RESIDENTIAL BUILDING PERMIT APPLICATION ON

B21001288_13001 Wainwright Road_Art Studio

Good morning. I just have 2 questions about your building permit for the proposed art studio over the existing garage.

51.01

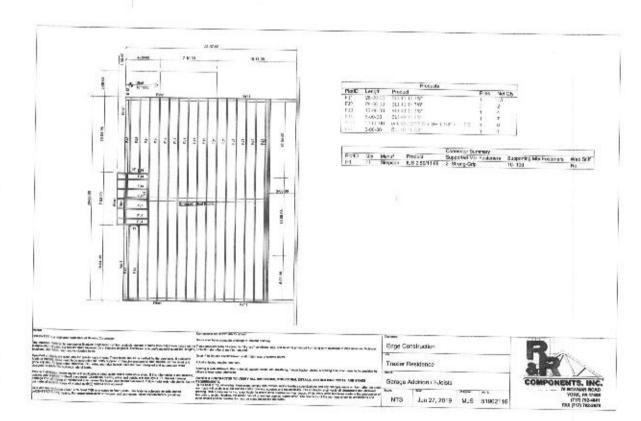
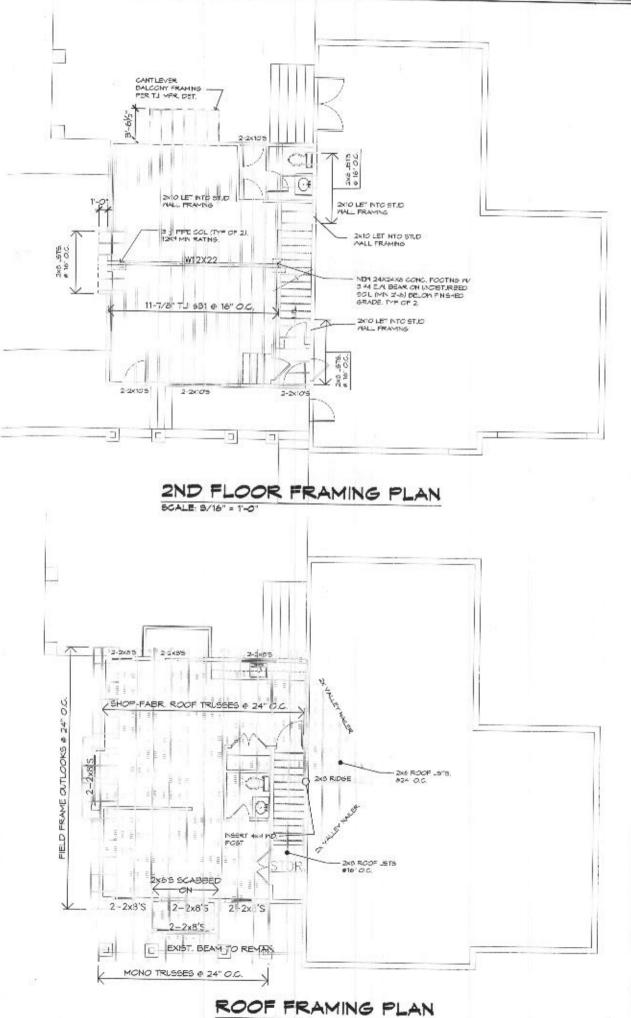
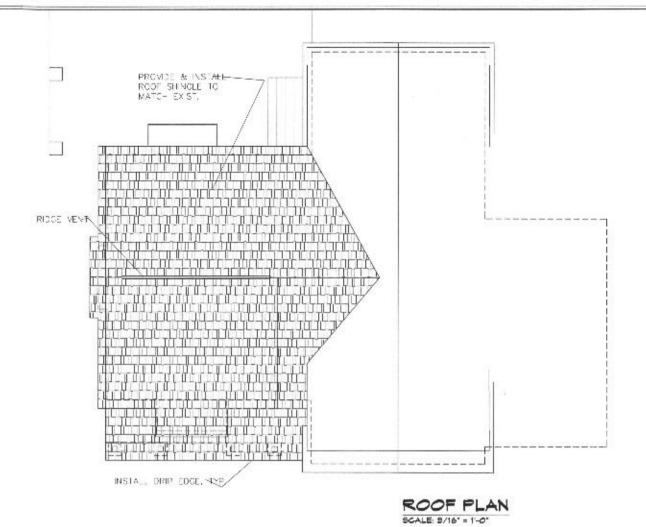
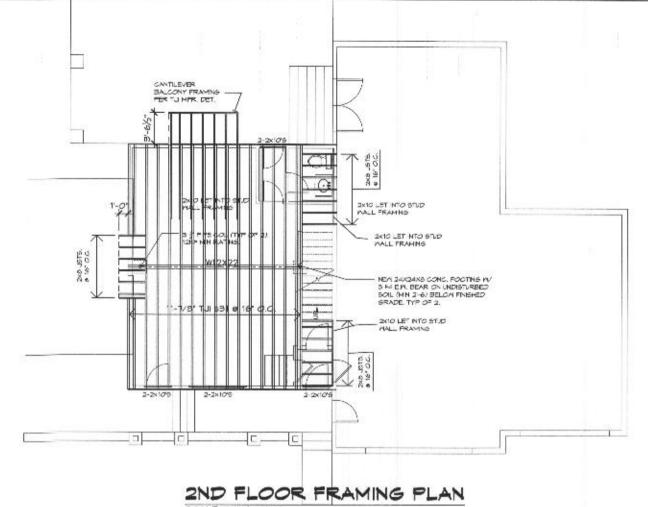
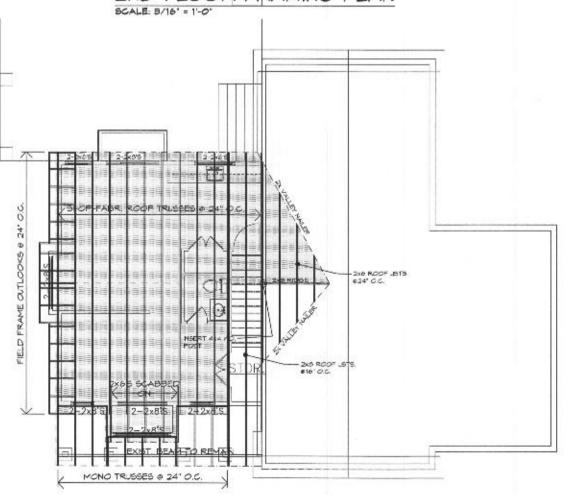
- 1.) Will the bathroom be a half or full bathroom? Page S1.01 shows a full bath w/ tub, but all other pages show a half bathroom.
- 2.) Will the art studio be used as a business or will it remain private?

- 1. The layout shown on the architectural drawings is correct. Bathroom is a half bath. There is no need for a tub or other large wash basin as the wash sink in the studio is more than sufficient for needed cleanups, etc. I have attached revised structural plans which have been corrected to reflect the proper layout should you need them.
- 2. Studio is to be used for private, personal hobby purposes.
